# Technical Bulletin 18-2

## INSTALLING CPI MODEL P55 PUMPS IN SKF/LINCOLN MODULAR LUBE LUBRICATORS

Technical Bulletin regarding the use of CPI's P55 vacuum pumps (model numbers 6501800P55V301S, V401S, V601S) with applicable Lincoln lubricator boxes.

Figure 2: Interference location between pump suction tube strainer and camshaft mounting block.

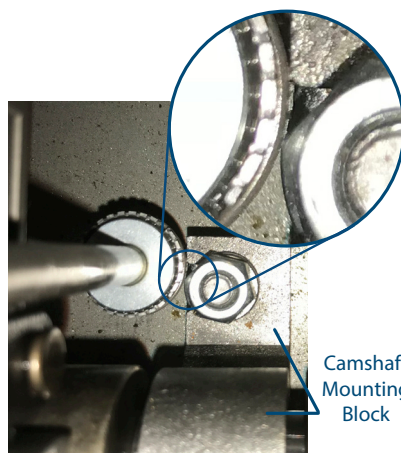
Interference may occur during pump installation between the pump suction tube strainer and the lubricator camshaft mounting block. The potential interference issue is limited to only the pump location adjacent to the lubricator camshaft mounting block (reference Figures 1-3). If the pump installs correctly in this location, then no further action is required. If the pump experiences interference during installation, the following options are recommended:

Option 1. Use a different pump location in the lubricator. This option requires rerouting the applicable discharge tubing line, but retains the pump suction tube strainer assembly.

Option 2. Remove the suction tube strainer assembly. Removing the strainer assembly is not an issue for applications using filtered, clean oil in the lubricator and routine maintenance practices. Grip the suction tube with pliers to prevent the tube unthreading from the pump body. Remove the strainer and unthread the strainer body from the suction tube (Figures 3-4). The suction tube is installed into the pump body with sealant to prevent vacuum leaks.
